Forced Performance 2004-2007 Subaru 2.5l Bulletin 12/1/07, UPDATE 9/1/08

Oil Starvation of Turbos on Subaru Vehicles: Why and How.

The turbocharger filter can be seen in the diagram below, it is marked "A"

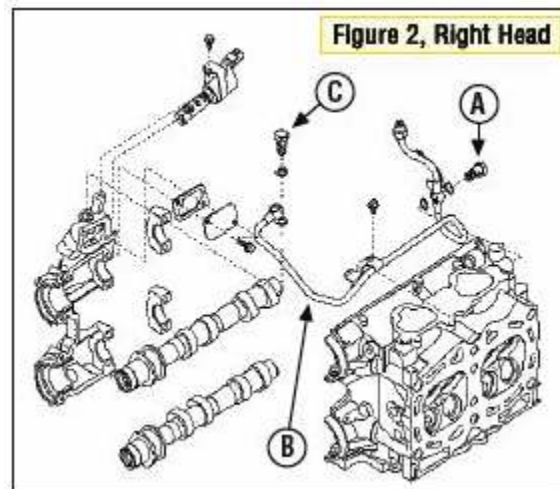
Forced Performance recommends REMOVING this "Turbocharger Oil Supply Mesh Screen" in all vehicles running our FPGreen and Red model turbochargers. The thrust bearing used in these turbochargers has very little tolerance for reduced or limited oil supply. In fact this bearing actually requires approximately TWICE the oil volume as a stock IHI turbocharger and can die a quick and sure death if fed its life giving oil through one of these restricted filters. It is also completely possible that a slightly restricted filter will

We also wish to point out that the picture of the banjo bolt and filter shown in the Service Bulletin appears to have the filter oriented BACKWARDS. To avoid confusion about which way to install the filter, simply eliminate the filter by picking it out of the banjo bolt and discarding it as soon as possible.

To clarify – REMOVE THE FILTER SCREEN FROM ALL BANJO BOLTS.
